Tsi107™ Revision 1.3/1.4 Device Differences

80C2000_AN002_02

November 3, 2009

Figure 1. Rev 1.3 and Rev 1.4 $\overline{\text{DBGn}}$ Signal Timing

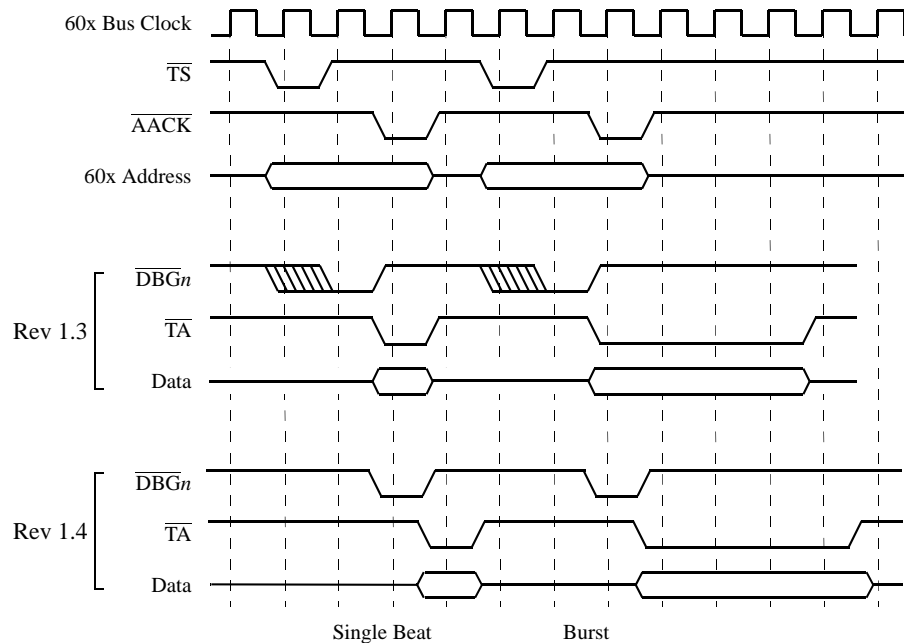
As described in Section 3.2, “MPC7450 Compatibility,” to guarantee that $\overline{\text{TA}}$ is not asserted on or before $\overline{\text{AACK}}$, the timings for $\overline{\text{DBGn}}$ and $\overline{\text{DBGLB}}$ were changed in Rev 1.4 to fix the MPC7450-compatibility problem. Before Rev 1.4, the Tsi107 may drive $\overline{\text{DBGn}}$ (and $\overline{\text{DBGLB}}$) as early as the cycle in which $\overline{\text{TS}}$ is asserted. Figure 1 shows the signal timing for $\overline{\text{DBGn}}$ and $\overline{\text{DBGLB}}$ on Rev 1.3 and Rev 1.4 devices.

For Rev 1.4 of the Tsi107, $\overline{\text{DBGn}}$ is asserted coincident with $\overline{\text{AACK}}$. If a Rev 1.3 system design incorporates external logic that depends on the timing of $\overline{\text{DBGn}}$ or $\overline{\text{DBGLB}}$, the external logic must be modified to accommodate the altered timing of Rev 1.4.
